CABELL-HUNTINGTON HOSPITAL
1340 Hal Greer Boulevard
Huntington, West Virginia 25701

December 27, 1988

Re: Amendment to Radioactive Materials License #47-00404-02

NEW DEPARTMENT

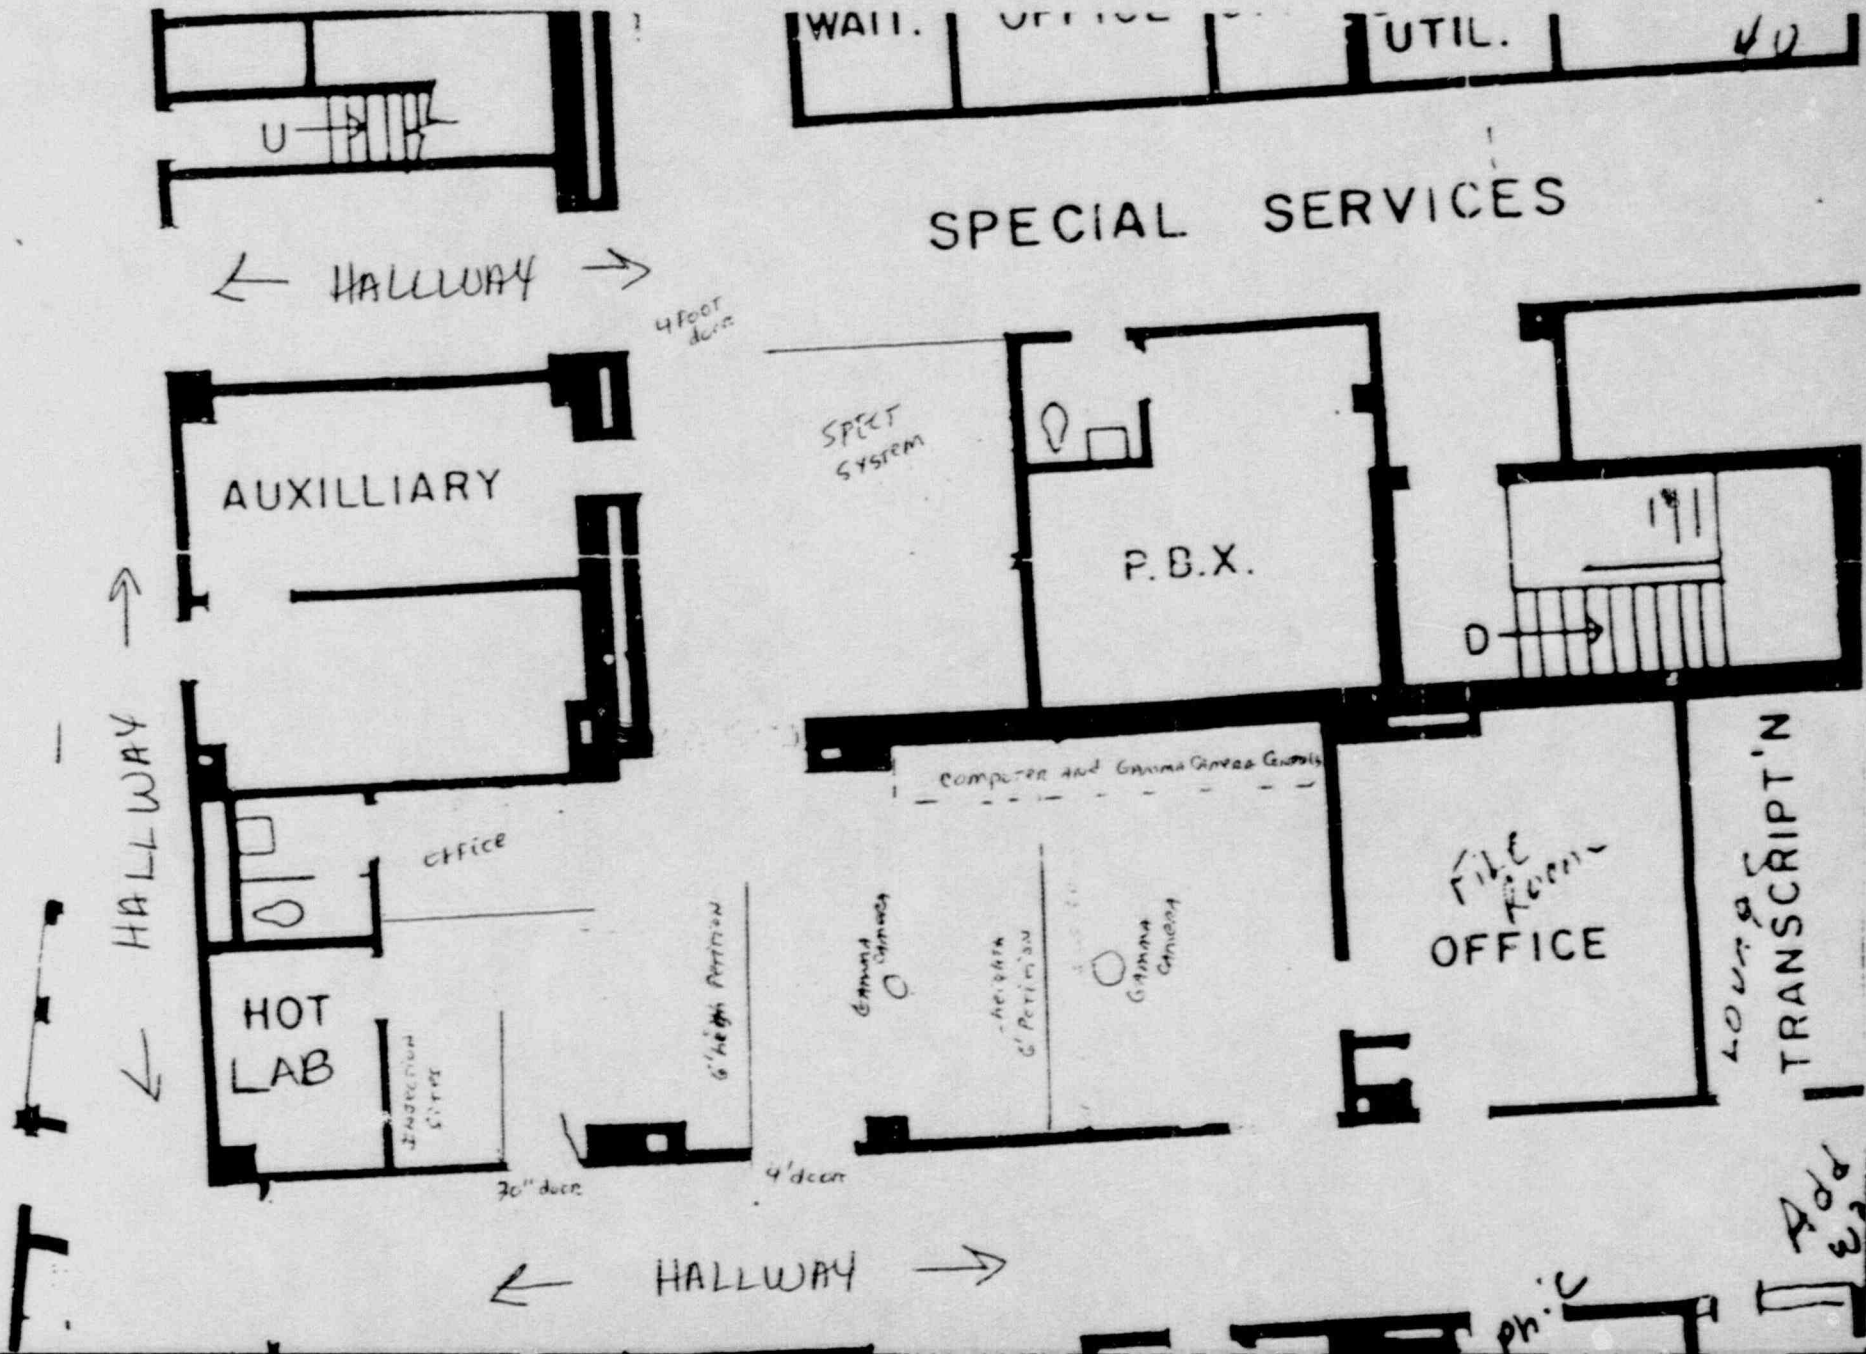
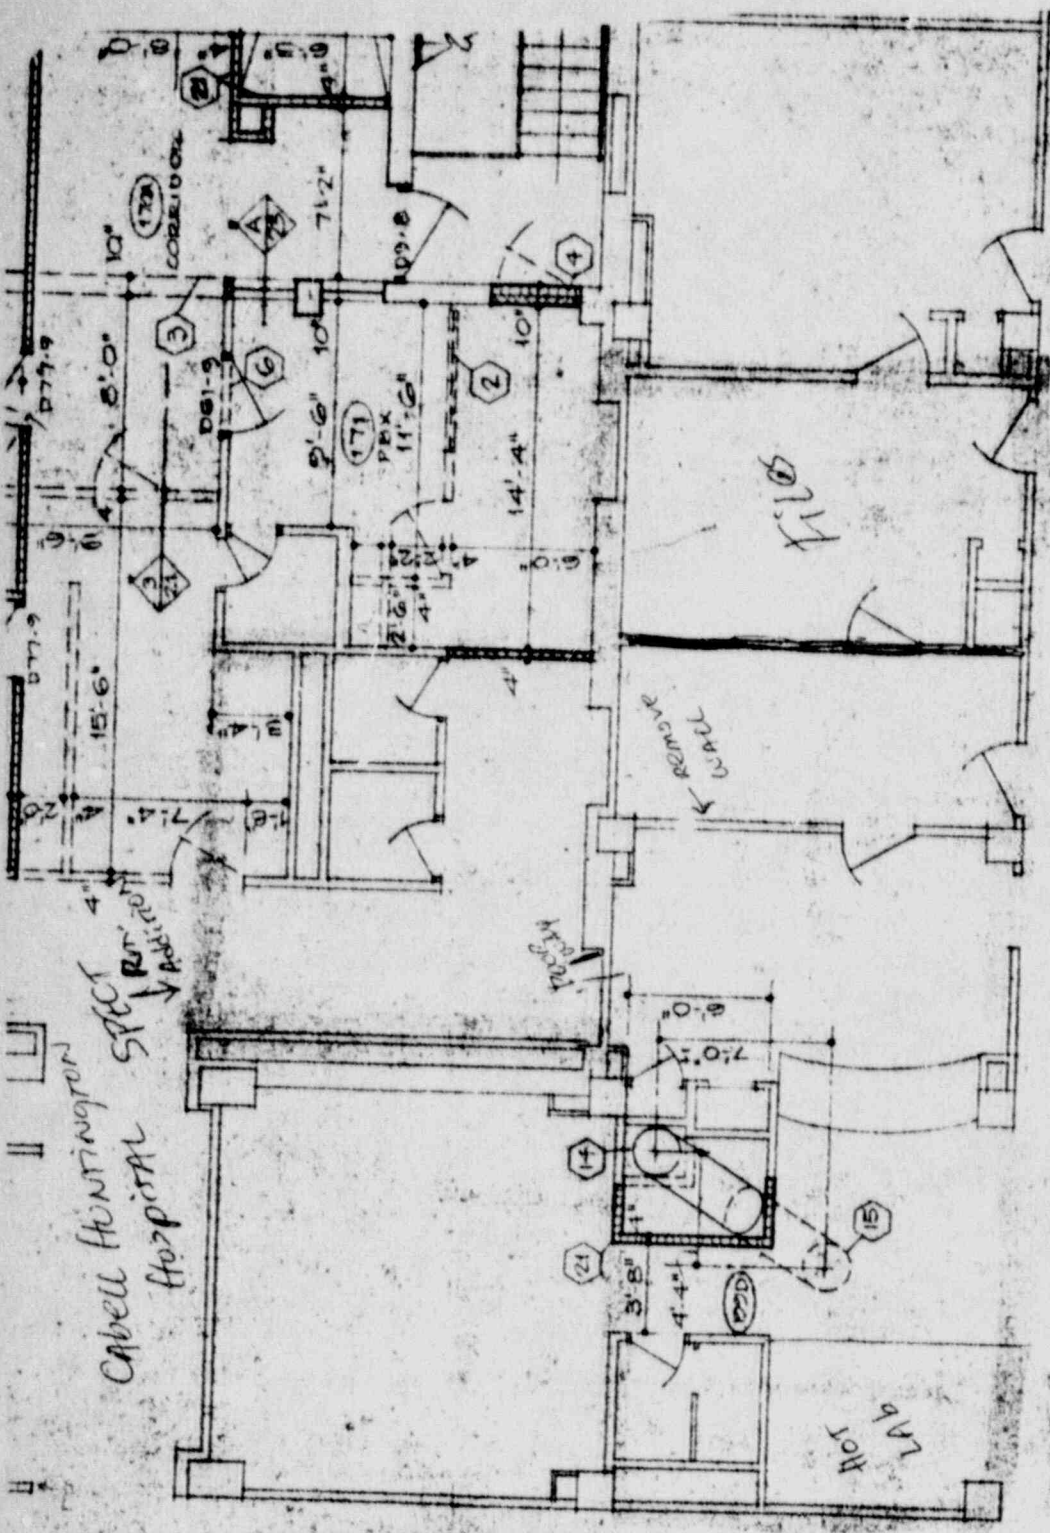
1. Our department will be expanding within the next few months. Please amend our license to reflect the expansion of our department. A new facility sketch is attached for your review.

2. Air flow rates will be determined in the new imaging room. The hot lab will be unchanged in it's location and will not be affected by the renovations. We will calculate the worker dose from Xenon-133, the public dose from airborne effluent, and the spilled gas clearance time for the department after the renovations are complete. These calculations will be on file for the NRC's review during inspections.

Cabell Huntington
Hospital
SPEC ROOM
APPROXIMATE

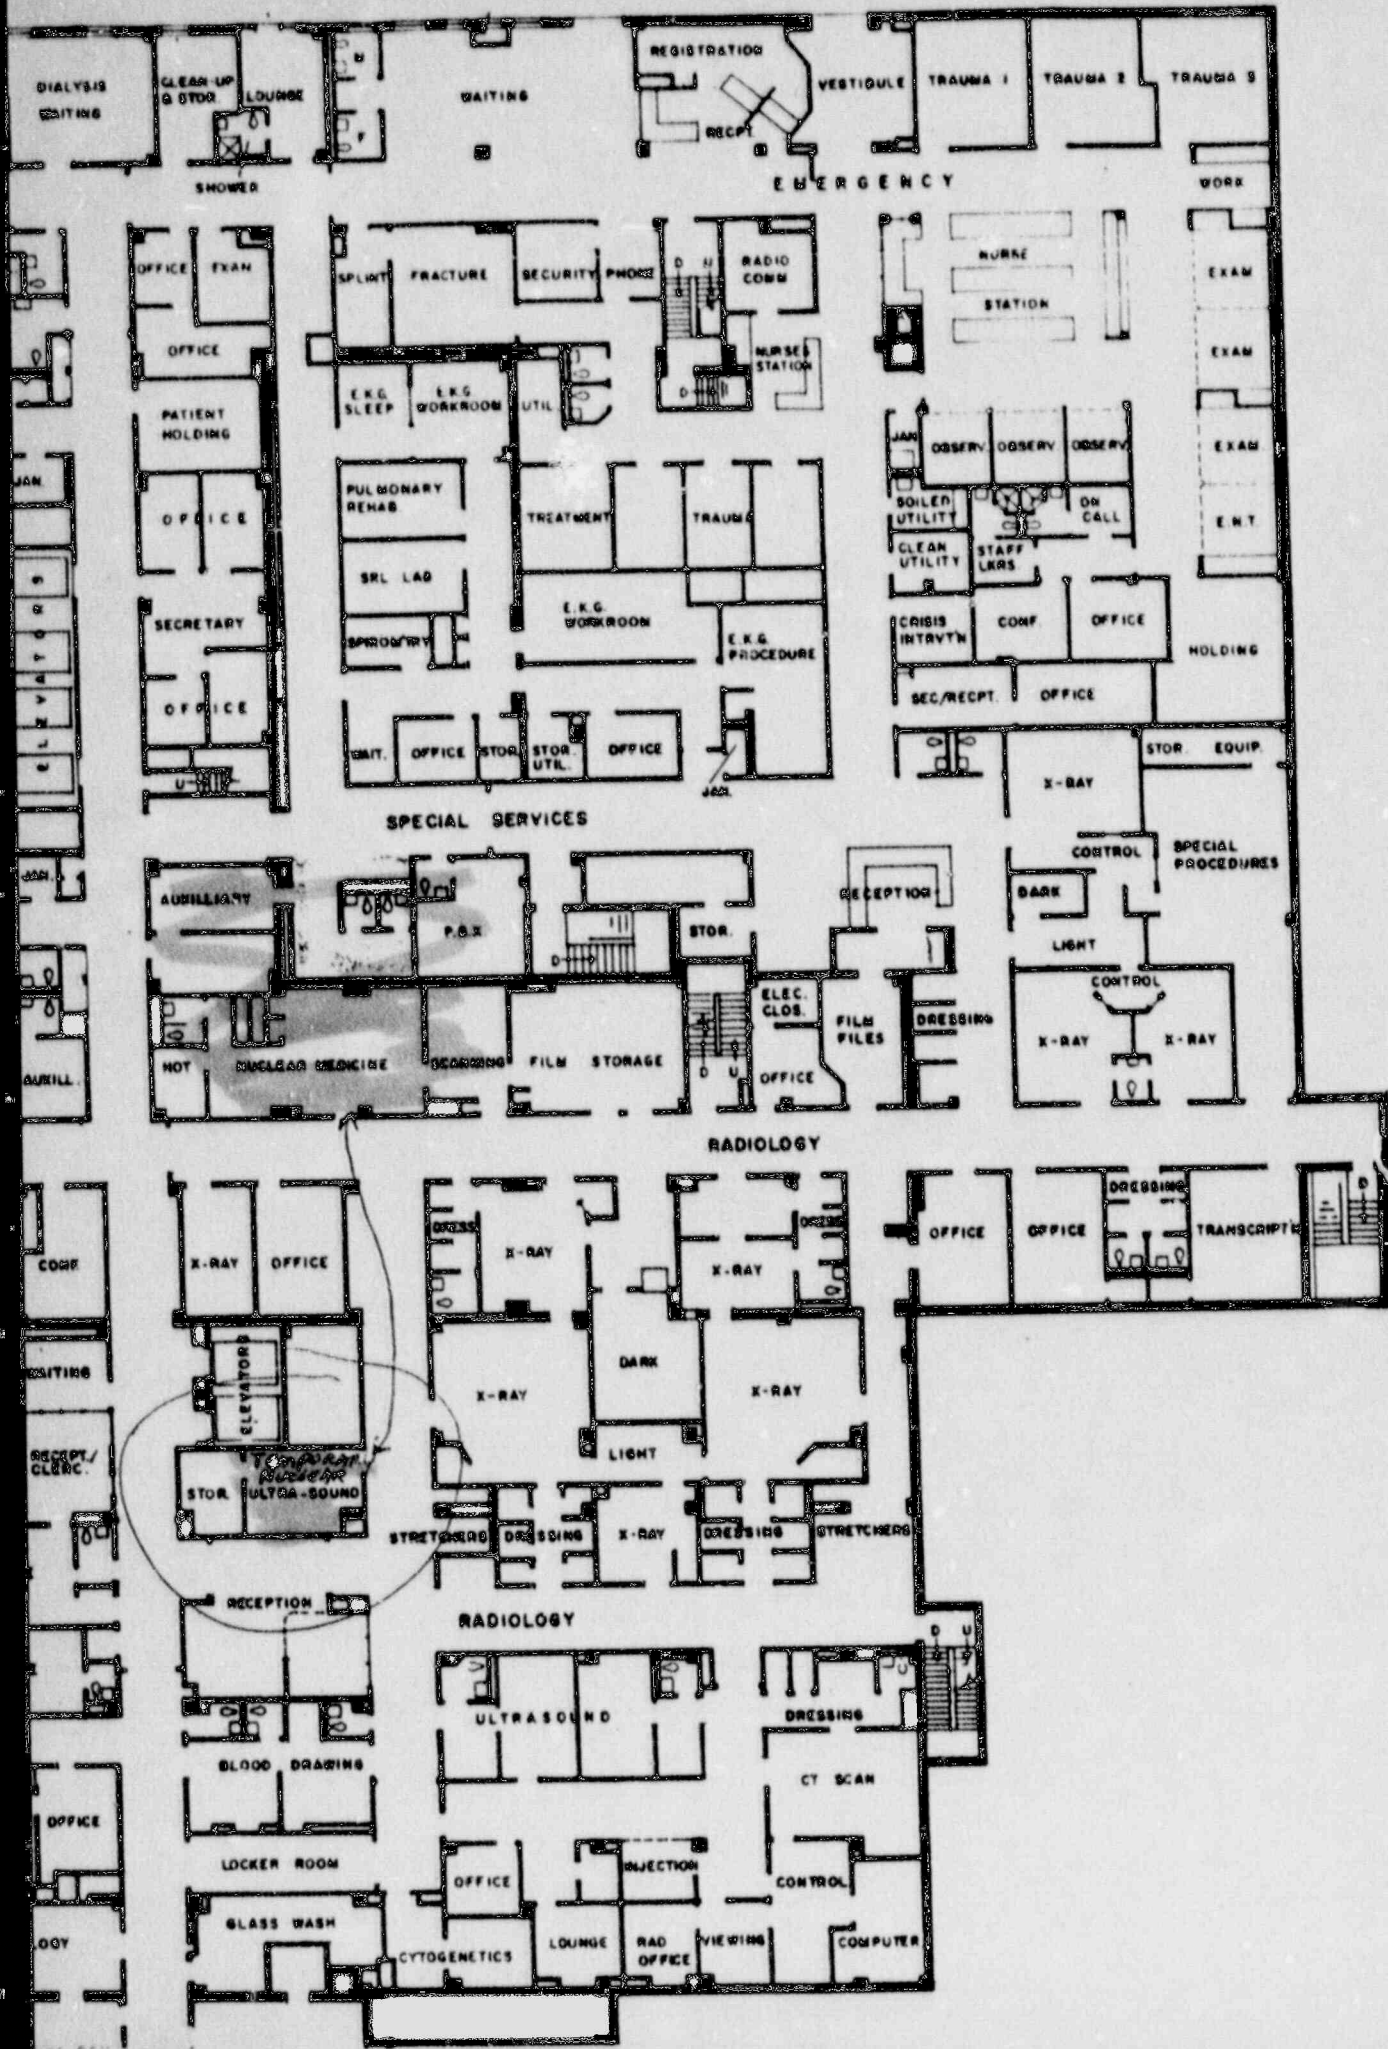
3. During renovations we wish to move one of our gamma cameras to a vacant room approximately 20 yards down the hall from our existing department. This will allow us to continue operations during renovations. We confirm that we will follow all radiation safety procedures the same as if this room was directly attached to our department. Radioactive material will be transported to this room in a leaded container. We will not use Xenon-133 in this room. Attached is a sketch of this temporary imaging room.

1989
New Department

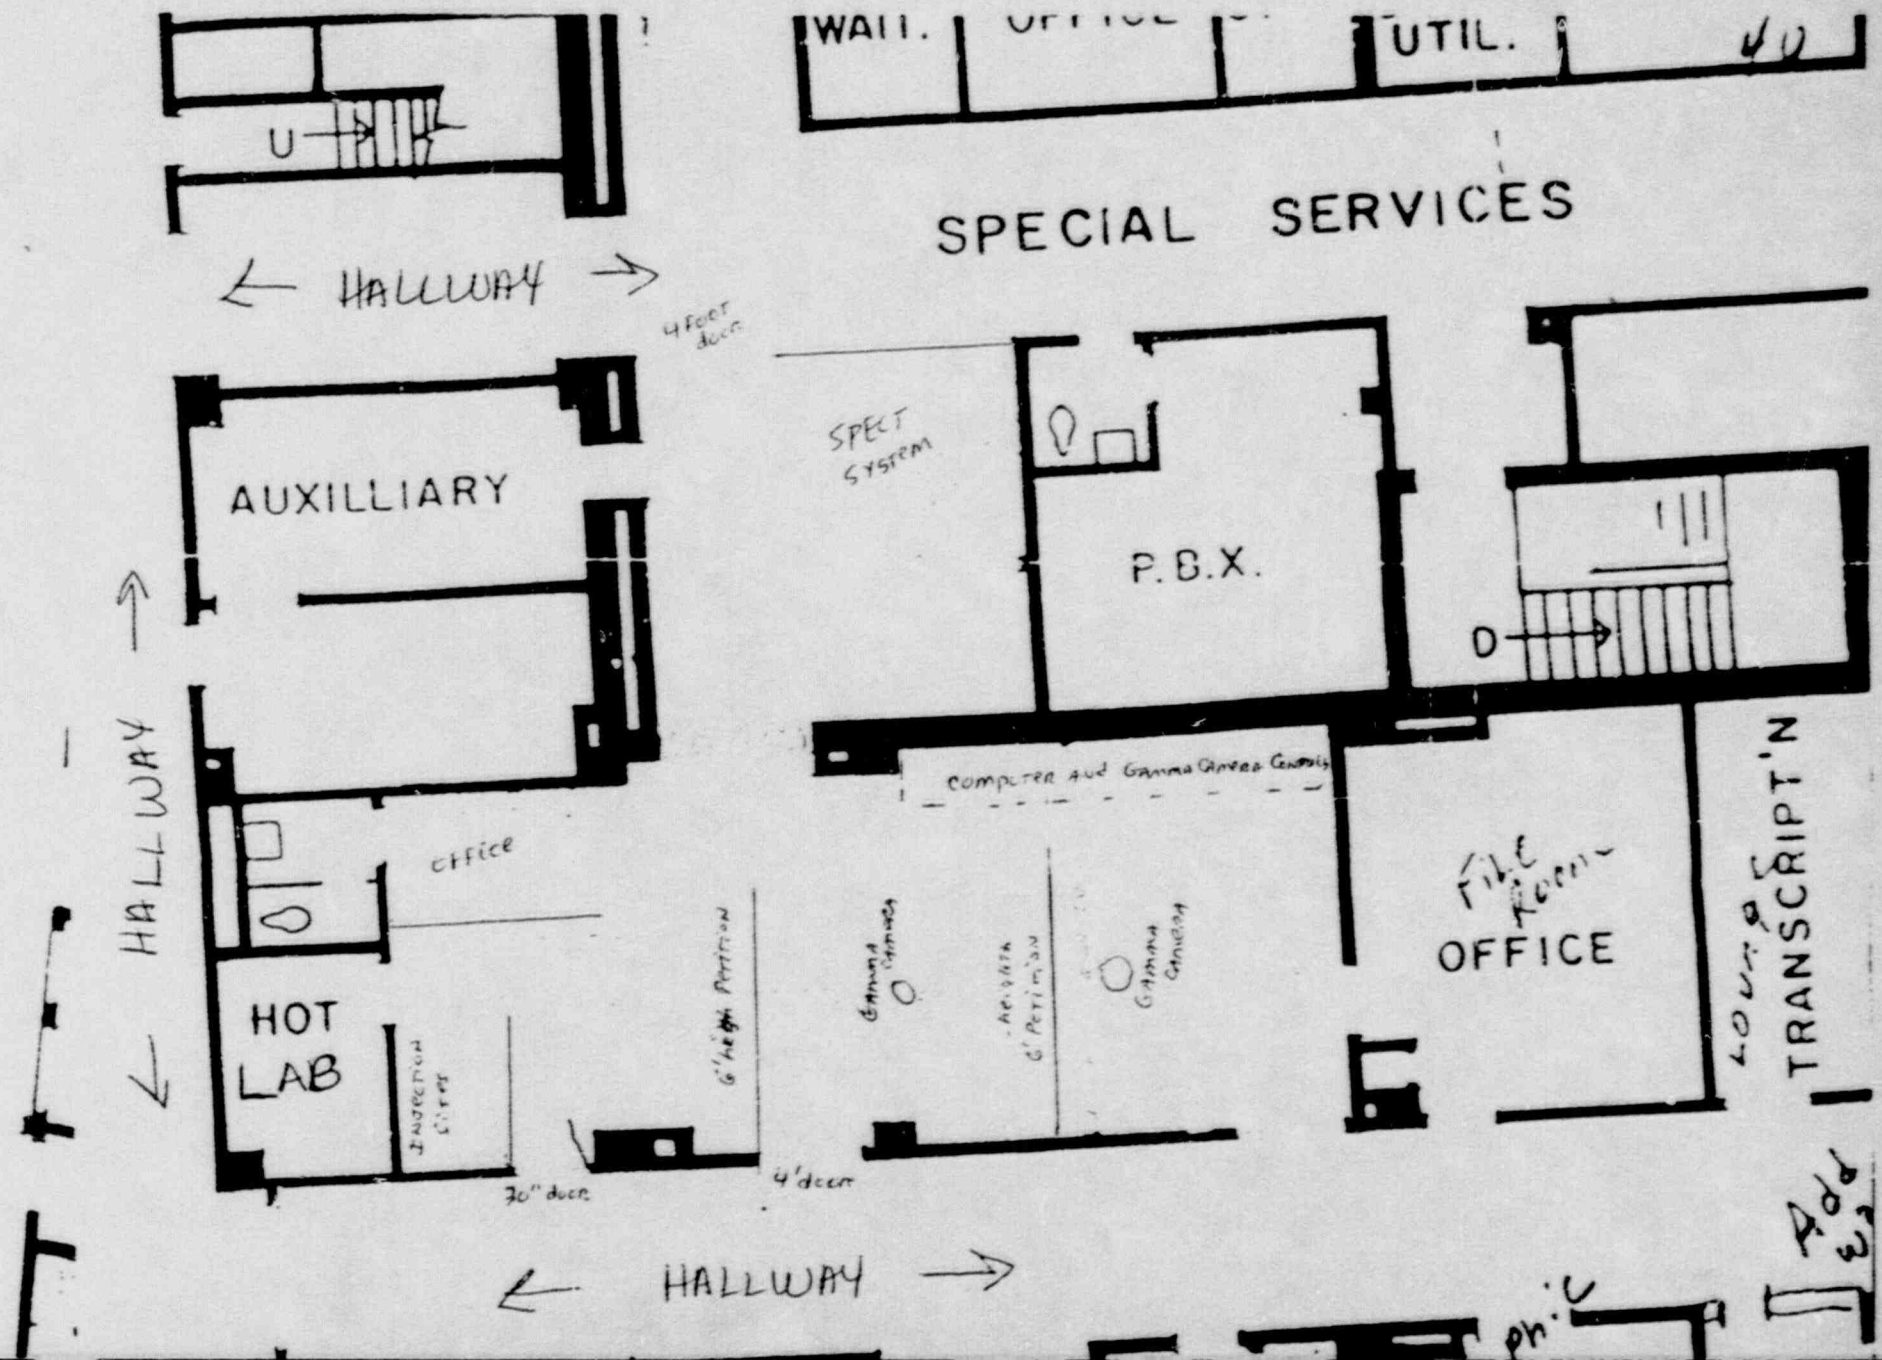
1. Our department will be expanding within the next few months. Please amend our license to reflect the expansion of our department. A new facility sketch is attached for your review.

2. Air flow rates will be determined in the new imaging room. The hot lab will be unchanged in it's location and will not be affected by the renovations. We will calculate the worker dose from Xenon-133, the public dose from airborne effluent, and the spilled gas clearance time for the department after the renovations are complete. These calculations will be on file for the NRC's review during inspections.
